Fermi 3

Fermi 3 Quality Assurance Program Description

Revision 1, Including
NDLCR-09-046-P02

Revision 1, including attached markups dated 9-30-2009 (NDLCR-09-046-P02).

**Figure II.1-1
Fermi 3 Pre-COL Organizational
Structure**

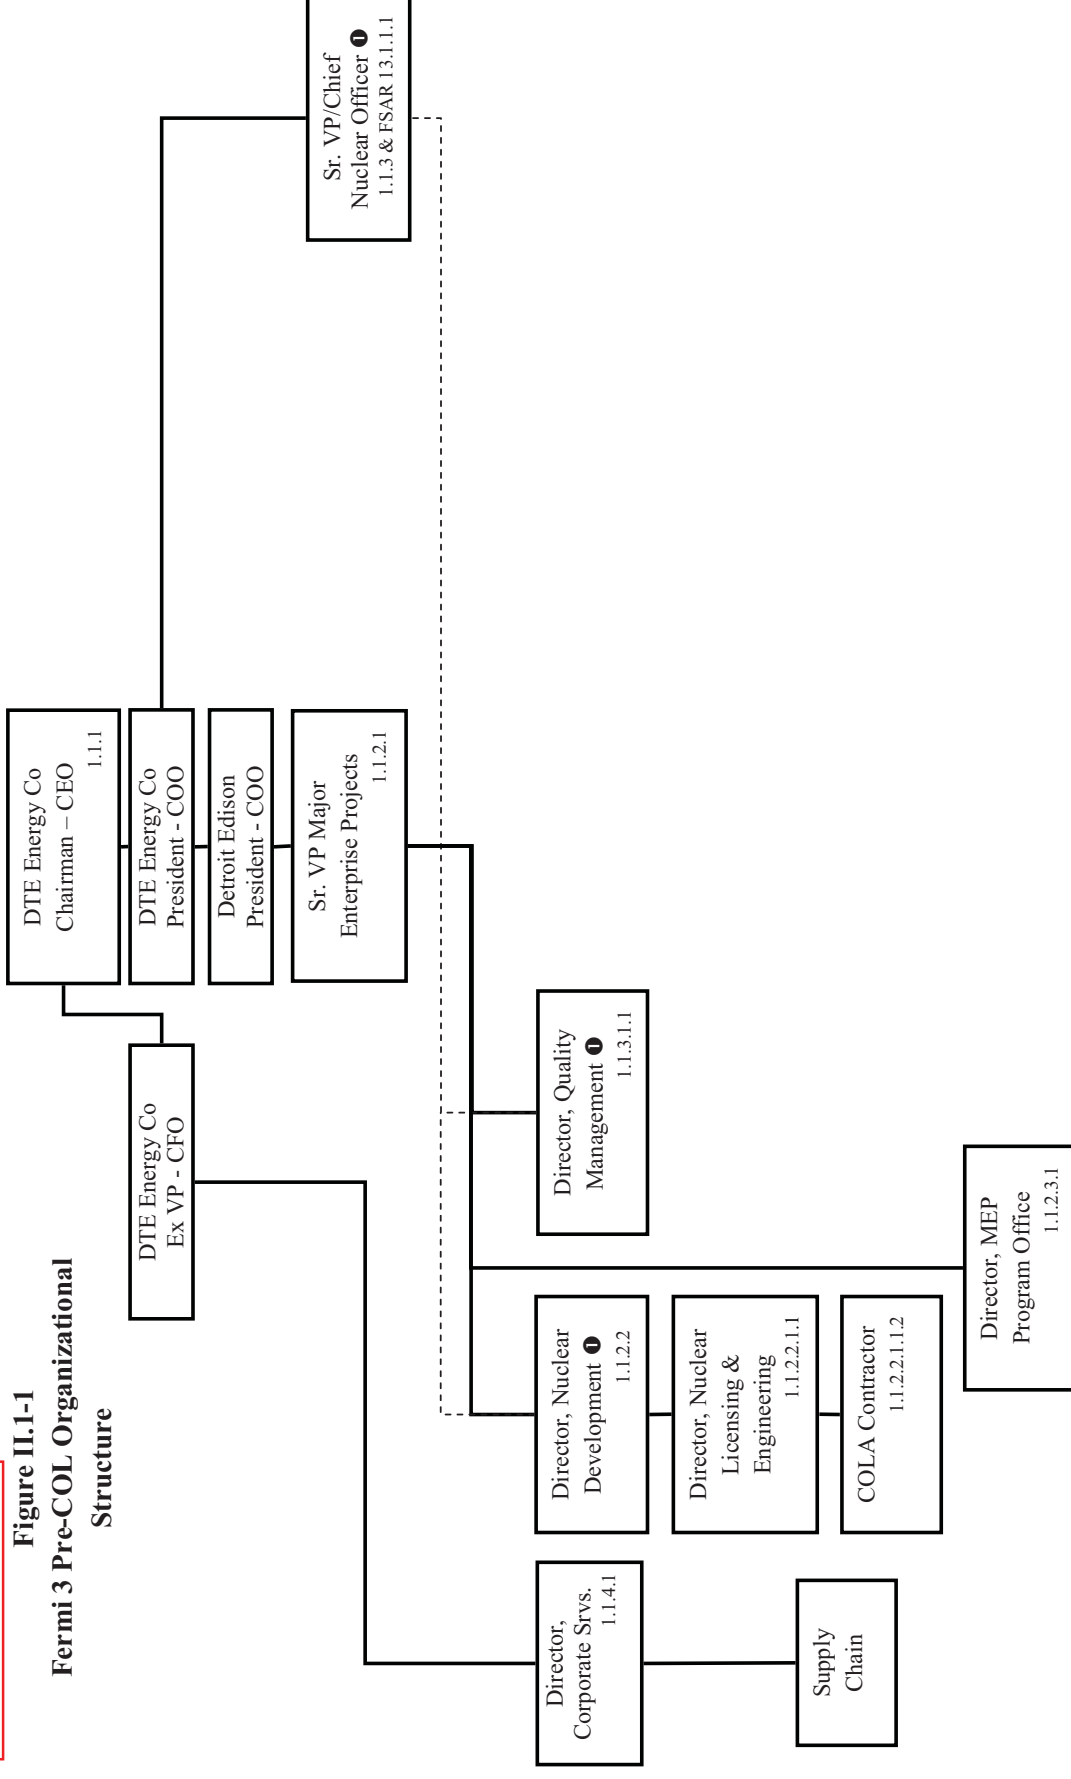
Delete Section 1 Organization, and replace with Insert 1

This section describes the organizational structure for the COL application activities of Fermi 3 and the Fermi 3 Pre-COL organizational structure is shown in Figure II.1-1.

Figure II.1-3
Fermi 3 Operating Organizational
Structure

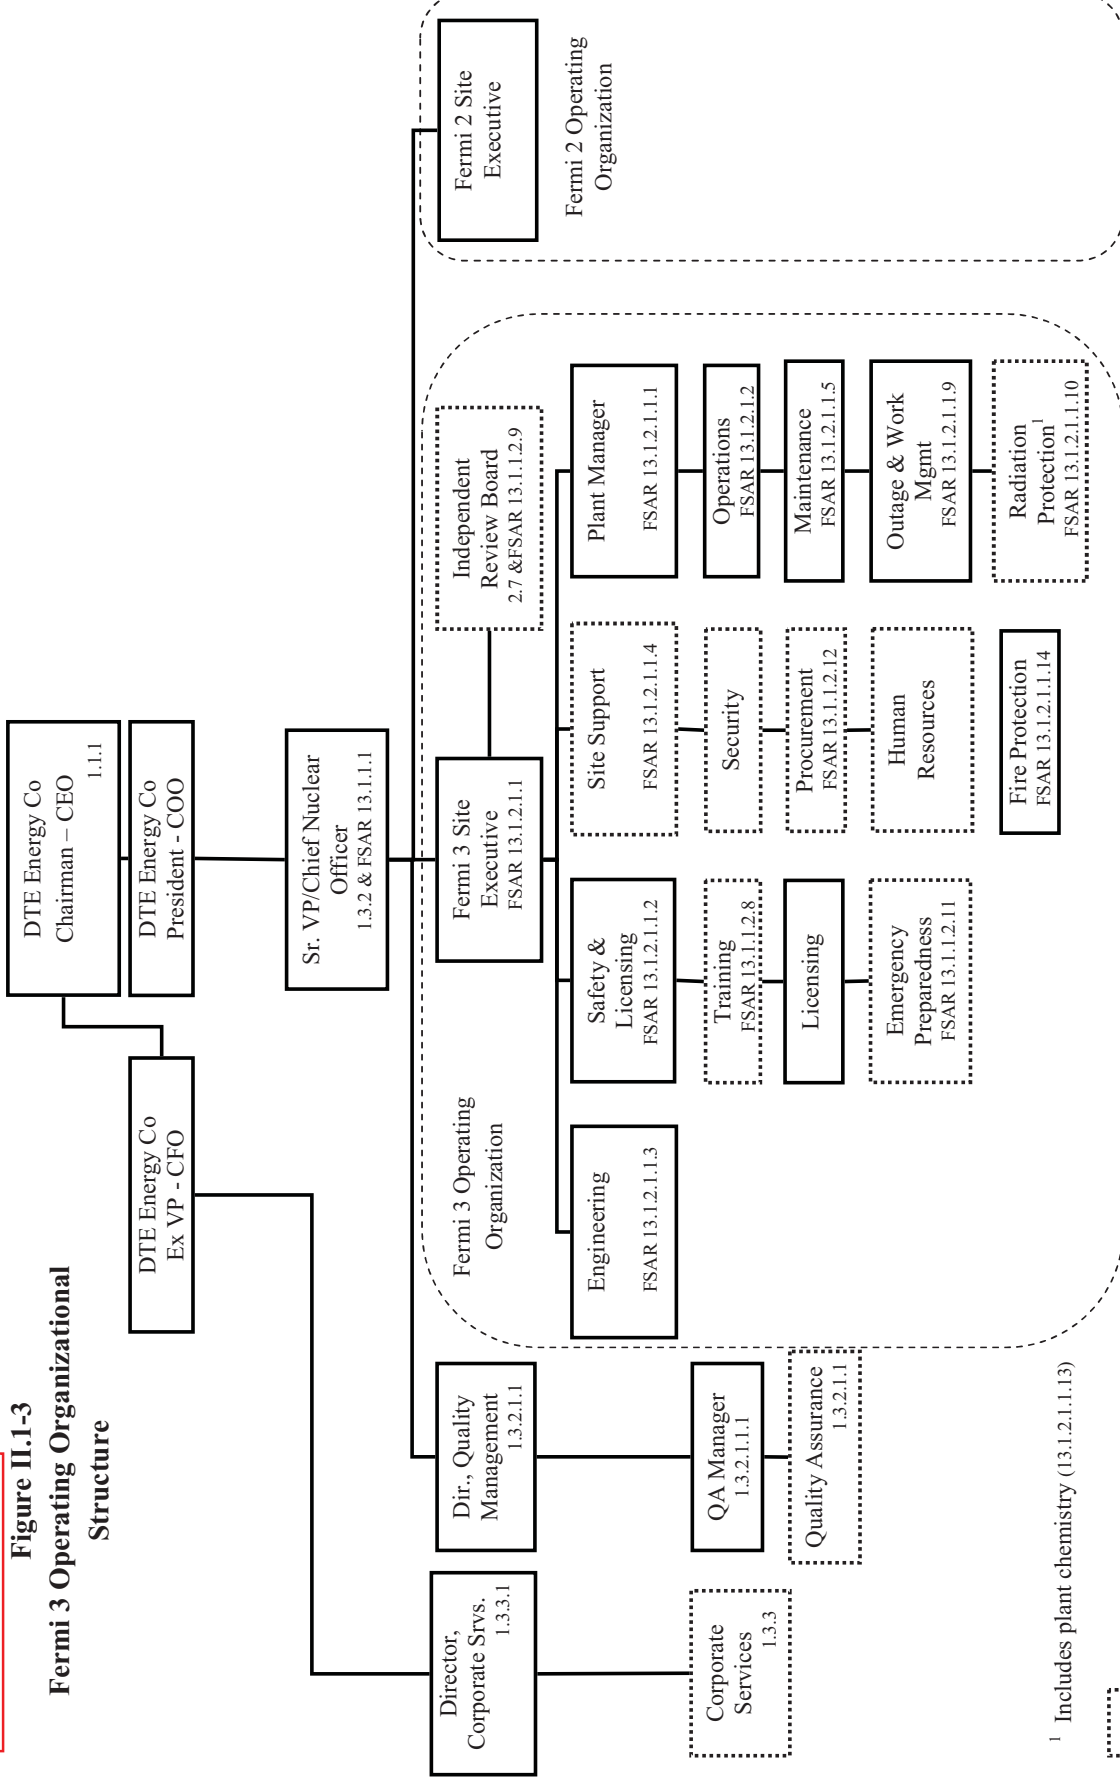
This section describes the organizational structure for the operational activities of Fermi 3 and the Fermi 3 Site organizational structure is shown in Figure II.1-3.
